Service Bulletin

PRELIMINARY INFORMATION

Subject: Revised Front License Plate Bracket Installation Instructions

Models: 2014 - 2015 Cadillac CTS Sedan (VIN A)
with Front License Plate Mounting Package (RPO VK3)

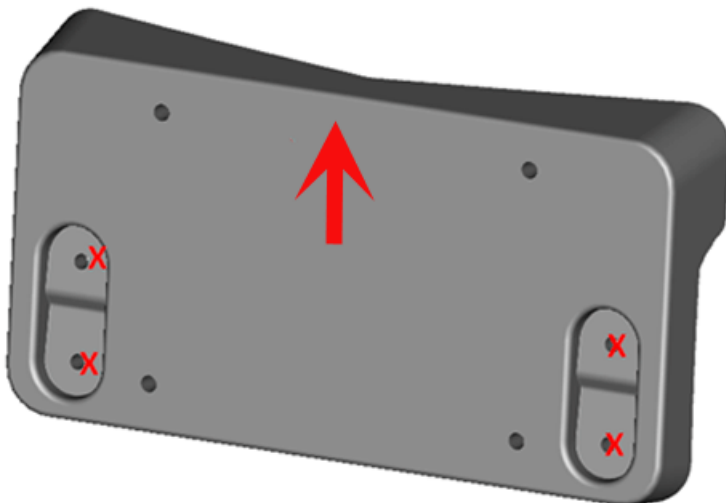
The installation of the front license plate bracket (if equipped) has been revised for better retention.

Do NOT use the rivets included in the trunk bag for installing the Front License Plate Mounting Package (RPO VK3).

If bolts and u-nuts are included in the trunk (small package with instruction sheet), use those to install the bracket following the instructions below.

If bolts and u-nuts are not in the trunk, order four (4) bolts and four (4) nuts to install the front bracket.

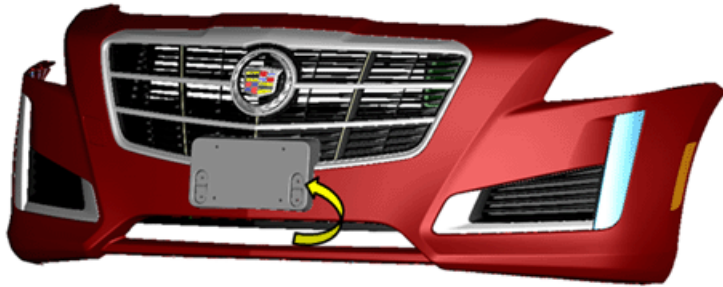
1. Drill 5.0 mm holes in all 4 location holes in bracket marked "X."

2. Install bolts through the license plate bracket and fascia holes.

3. Reach inside and behind the fascia (through the lower fascia opening) and install u-nuts on the backside. The u-nut is being used only as a nut, it does not clip on to any body parts.
4. Tighten bolts into u-nuts with a torque of (22 in lbs.) or (2.5 nm.).

Note: The license plate bracket **MUST** be mounted as shown above so that airflow through the fascia is not restricted and proper engine cooling occurs.
